Re: Chevron Service Station # 9-1924

Address: 4904 Southfront Road, Livermore, California

Re: **Response to Comments**  
Chevron Service Station #9-1924  
4904 Southfront Road  
Livermore, California  
Fuel Leak Case No. RO0000477

**2**

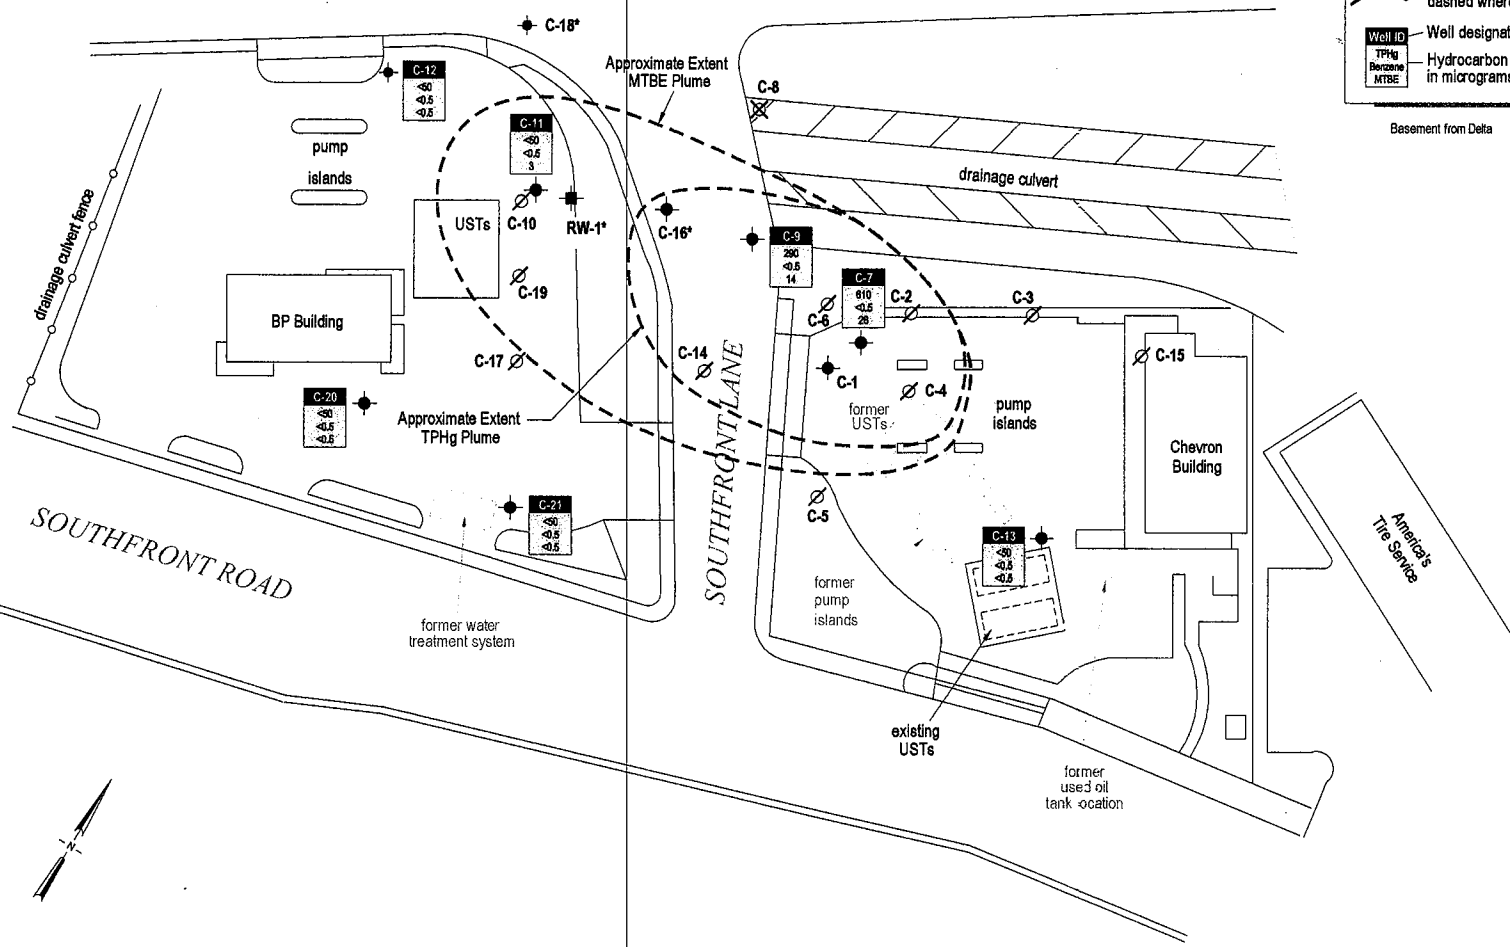
The hydrocarbon and MTBE plumes extending downgradient of the subject site have generally declining concentration trends. Based on their current extent as shown on Figure 2 and that they appear to be shrinking, it is unlikely that the plumes will impact, or their migration will be influenced by the former irrigation and domestic wells identified in Delta Environmental Consultants, Inc., December 10, 2002, *Site Conceptual Model*. Additional information on these wells is not necessary as they have no bearing on the improving groundwater conditions at the site.

extent approximately 150 feet downgradient of the subject site (Figure 2) and appear to be shrinking, potential impact to lower water-bearing zones is unlikely.
